HISTORIC AND DESIGN REVIEW COMMISSION

HDRC CASE NO: 2017-069
ADDRESS: 3100 BROADWAY
LEGAL DESCRIPTION: NCB 3864 BLK 10 LOT 7 THRU 12
ZONING: C-2 RIO-1
CITY COUNCIL DIST.: 2
APPLICANT: Jason Fuege/Mdn Architects, Inc
OWNER: Jason Fuege/Mdn Architects, Inc
TYPE OF WORK: Construction of an addition to an existing structure, site work
REQUEST:

1. Construct an addition to feature 1,800 square feet to the existing 3,000 square foot structure.
2. Perform site work including landscaping, parking improvements and drainage studies.

Sheet Title:
LANDSCAPE PLANTING PLAN

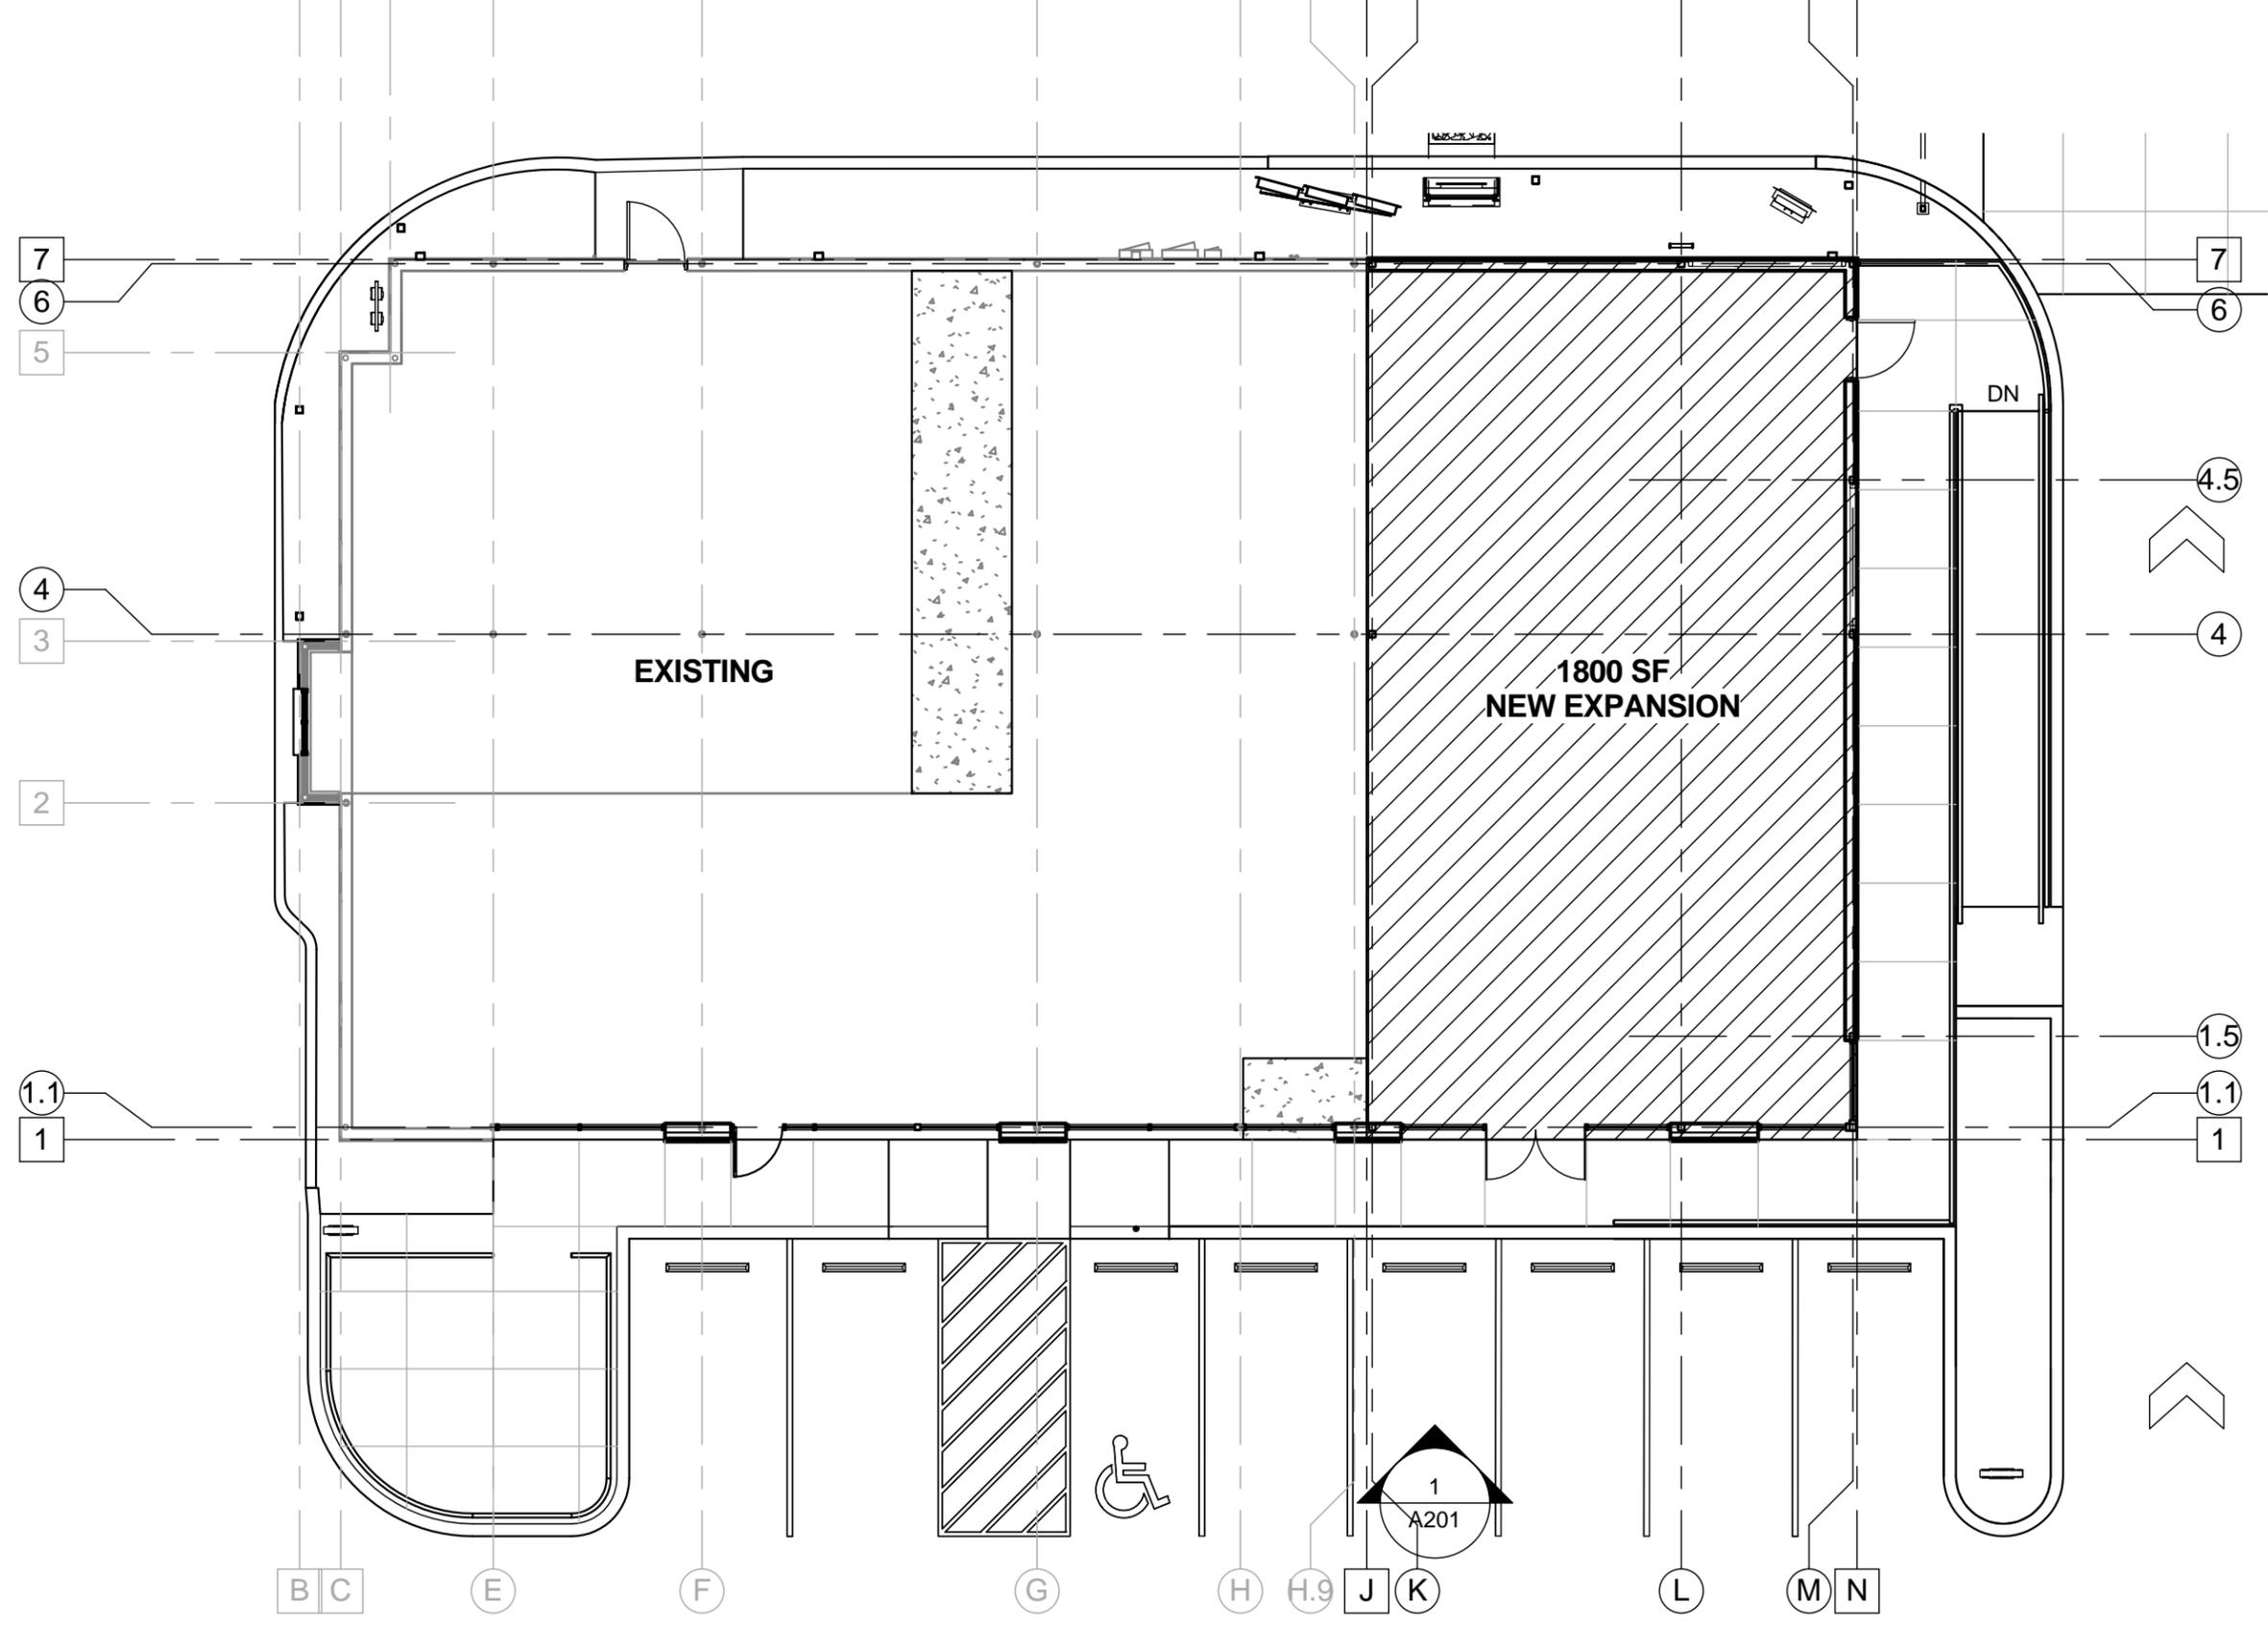
- d. LANDSCAPING – Along the public right of way on Ira, the applicant has proposed to install various plant materials including a Shumard Oak, Mexican Sycamore, Bur Oak, three Lacy Oaks, three Mexican Olives and three Mountain Laurels. In addition to the previously mentioned trees, the applicant has proposed to install various other plants to provide ground cover both along the public right of way and at the commercial structure. This is consistent with the UDC Section 35-673(f).

project #: 2015128
date: 10/28/16
reviewed by: JF
drawn by: JAP
drawing title: EXTERIOR ELEVATIONS
drawn number: A201

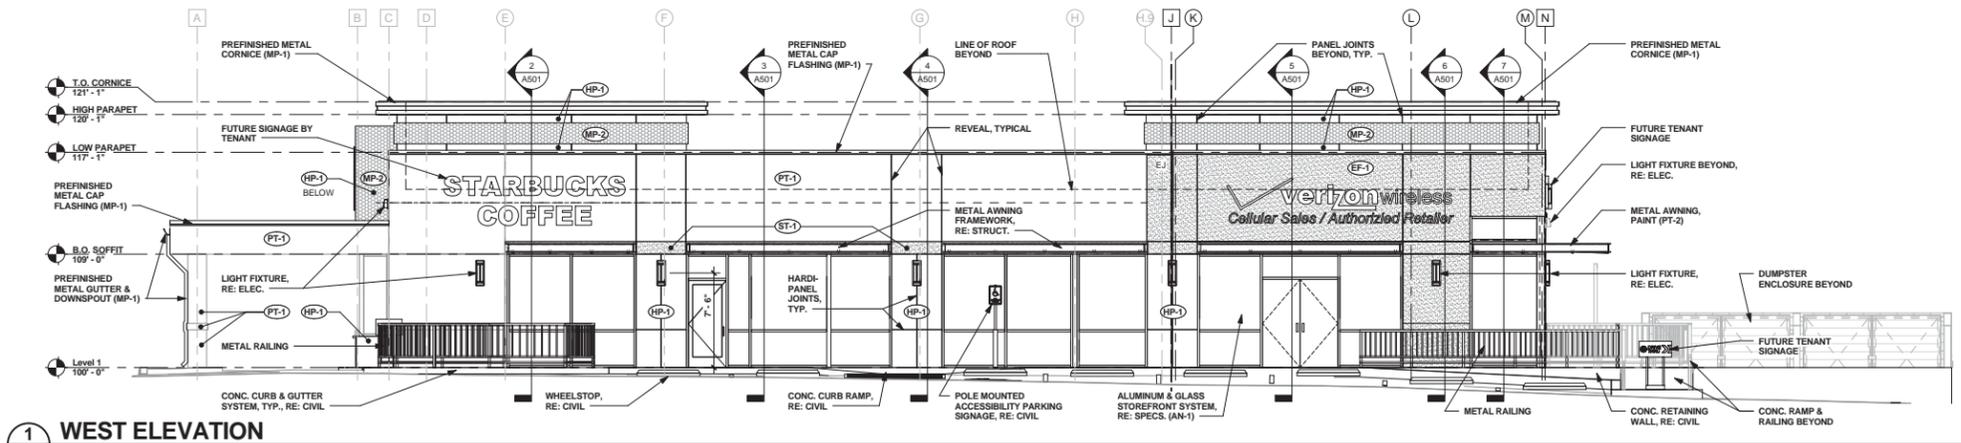
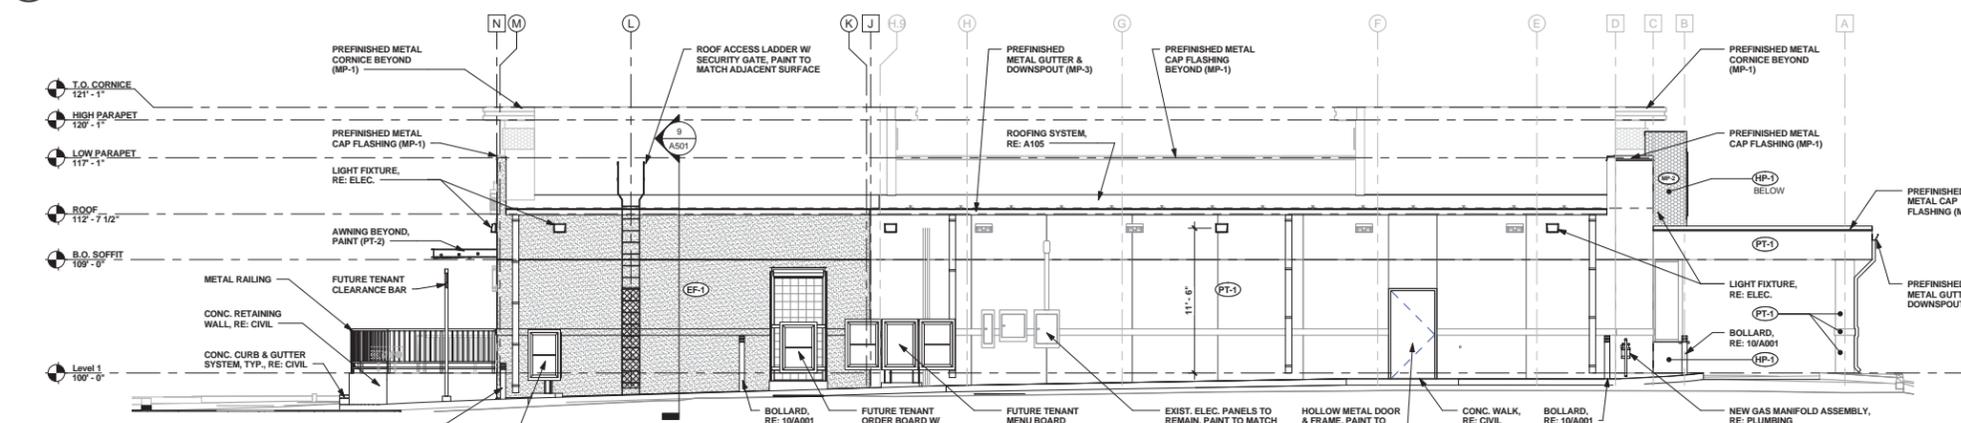
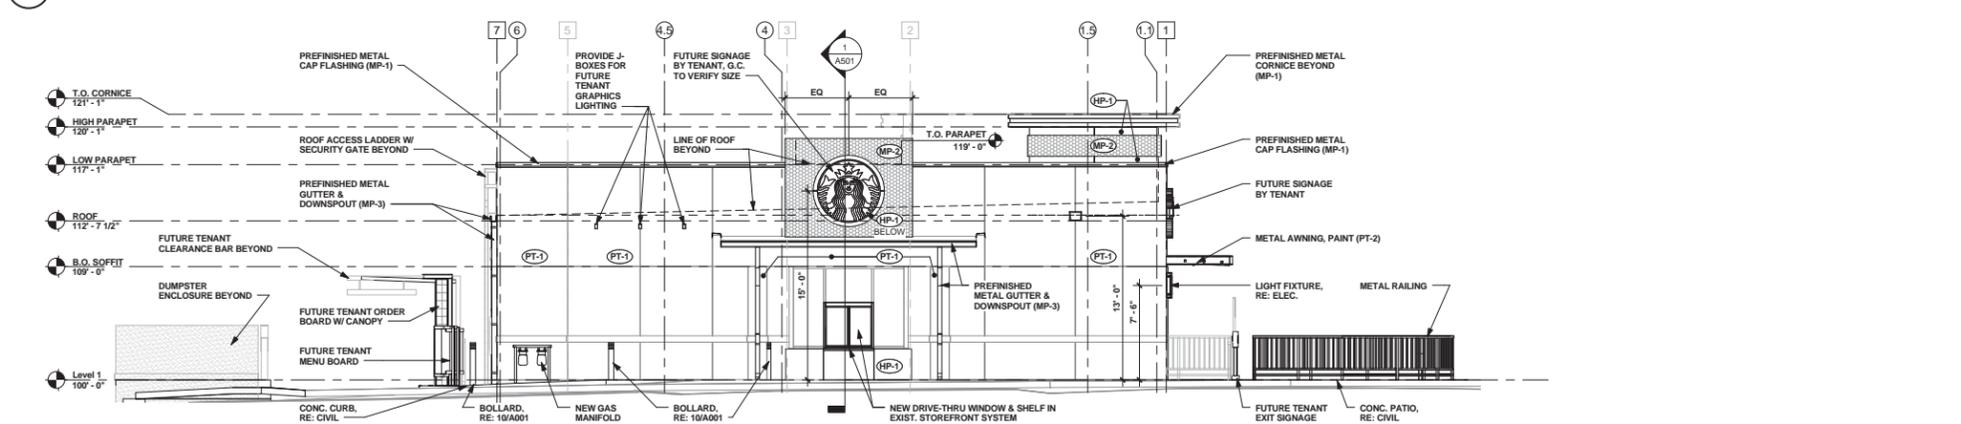
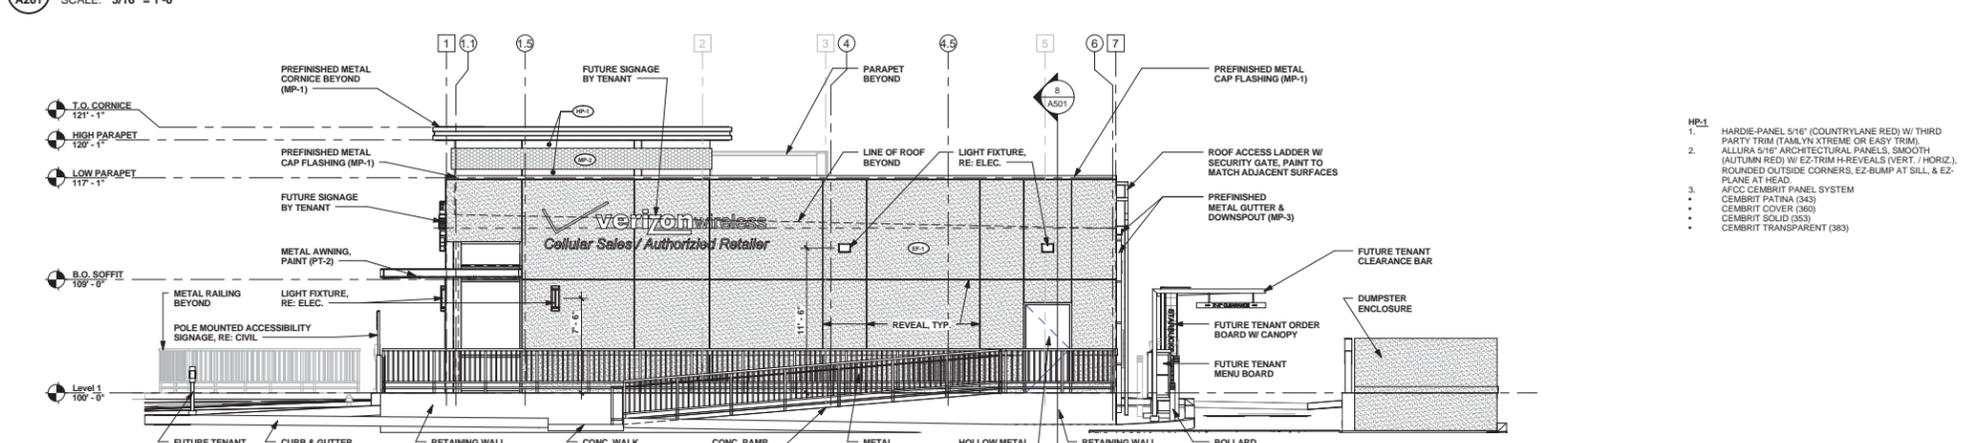
- h. ADDITION – The applicant has proposed an addition to the south side of the existing structure that is to feature a massing and materials that are consistent with existing structure. The applicant has proposed to modify the existing structure’s architectural elements to coincide with the added massing and façade length. The applicant has oriented entrances in an appropriate manner that is consistent with the UDC.

- i. ADDITION – Per the UDC Section 35-674(b), all building should appear to have a human scale. In general, this scale can be accomplished by using familiar forms and elements interpreted in human dimensions. Facades shall contain a discernible pattern of mass to void, or windows and doors to solid mass. Opening shall appear in a regular pattern or be clustered to form a cohesive design. The applicant has proposed the installation of entrance canopies which provide façade separation creating a more apparent human scale. This is consistent with the UDC.

- j. ADDITION – The UDC Section 35-674 (b)(4) notes that a façade in RIO-3 that features more than thirty (30) feet in length should be divided into modules that express traditional dimensions. The applicant has incorporated bays of storefront systems with corresponding entrance canopies and alternating façade materials. This is consistent with the UDC.

- k. MATERIALS – The applicant has proposed materials that include aluminum storefront systems, a stucco finish and accent of perforated metal bands and cement boards. Staff finds the proposed materials appropriate.

- i. That the applicant screen all mechanical equipment from view at the public right of way.
- ii. That the applicant present a master signage plan noting all proposed wall signage, window signage, monument signage and vehicular oriented directional signage. No signage is to be permitted or installed prior to being reviewed as part of a master signage plan by the HDRC.
